ORIGINATION FORM

Proposed Revisions to a Standard Plans Index
(Please provide all information — Incomplete forms will be returned)

Index Number: 521-422

Index Title: Traffic Railing - (42" Vertical Shape)

LAST REVISION 11/01/18	REVISION	DESCRIPTION:	 FY 2020-21 STANDARD PLANS	TRAFFIC RAILING - (42" VERTICAL SHAPE)	INDEX 521-422	SHEET 1 of 3
---------------------------	----------	--------------	--	---	------------------	-----------------

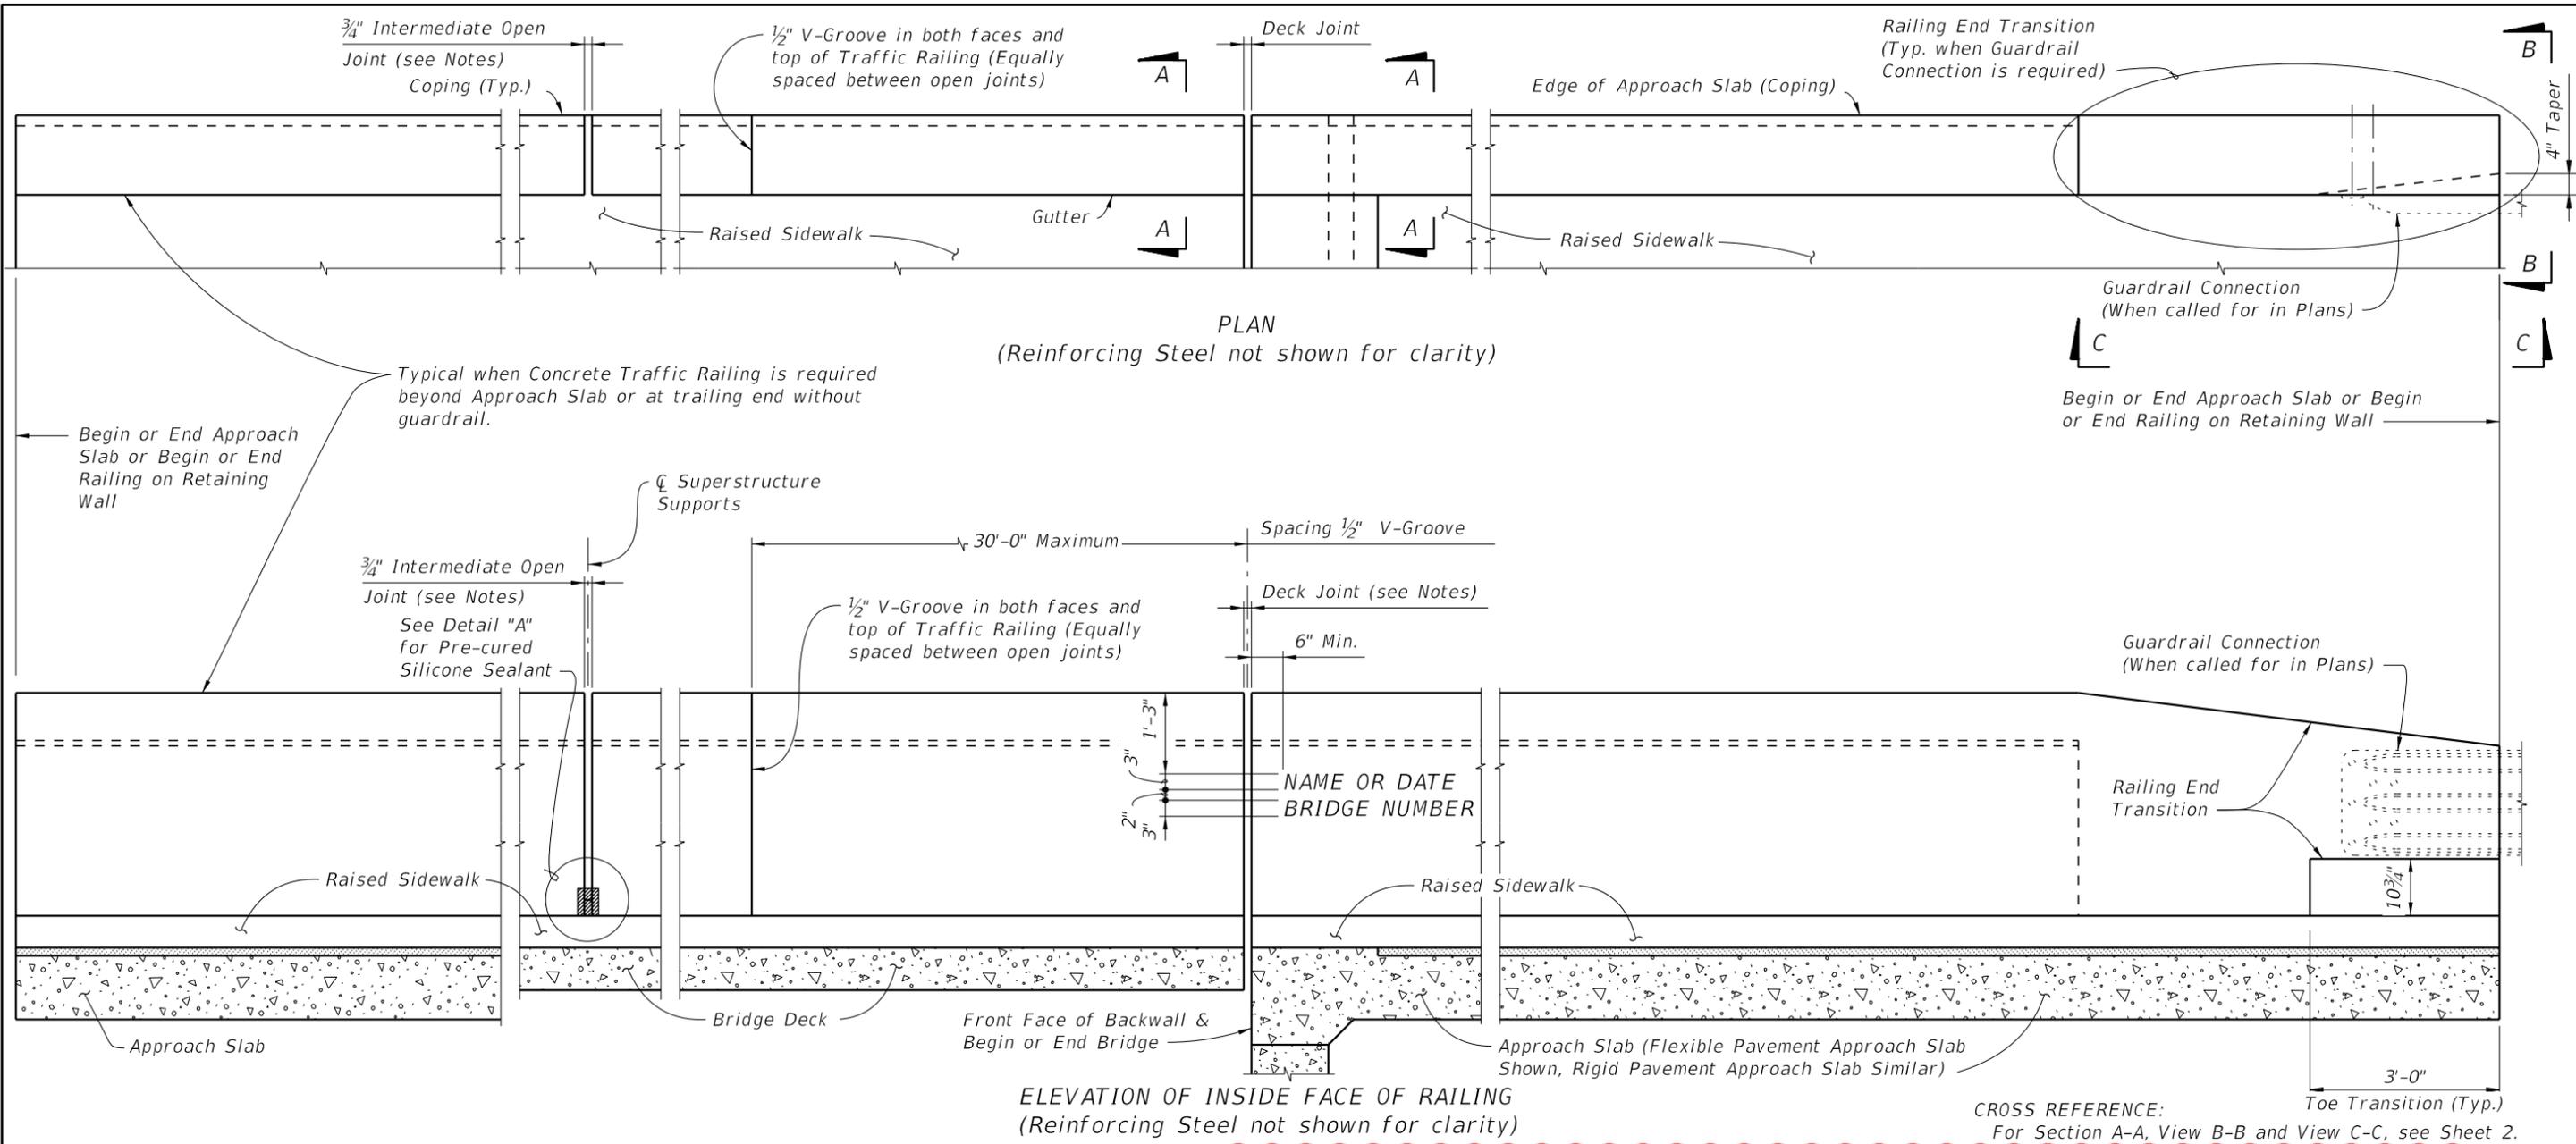
Numbered and reorganized Notes; Deleted MASH note.

MASH crash criteria met is in the SPI (not a construction note). Numbered notes to make them consistent with other Indexes.

~~This railing has been structurally evaluated to be equivalent or greater in strength to other safety shape railings which have been crash tested to NCHRP Report 350 TL-4 and MASH TL-4 Criteria.~~
